From: Ellen Shipley <yikido@gmail.com>
Sent: Wednesday, 23 March 2016 7:32 AM
To: Alastair Swain; Brian Candler; Clinton Jacka; David Ritchie; Ellen Shipley; Hobbes David; Joseph Nadler; Louise Curham; Peter Shaw; Tanya Wordsworth
Subject: Structures application from unit 52

Lang objection to #52 plans – 23 March 2016

Three Separate Urambi Structures Applications House 52

Application 2 (Laundry window)

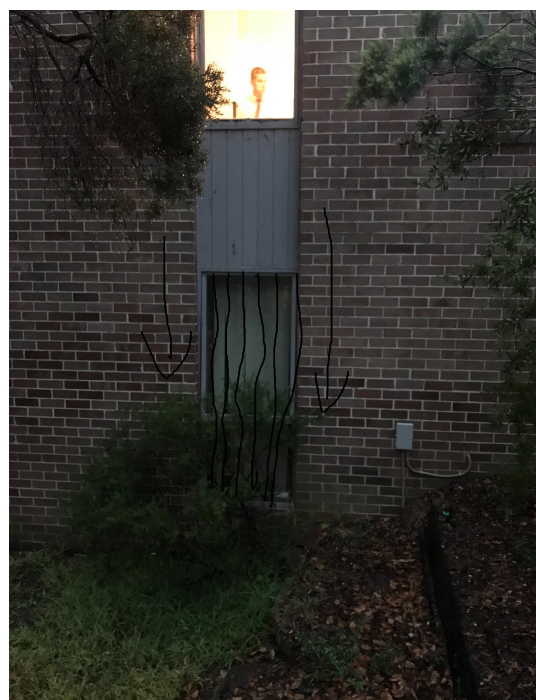
The owners of house 52 would like to brick in one of the three windows in their laundry. A new two-bay window will be installed. This window is not visible to residents as it opens to an enclosed front courtyard and garden bed. The window to be removed is indicated by the crossed section in the photograph.
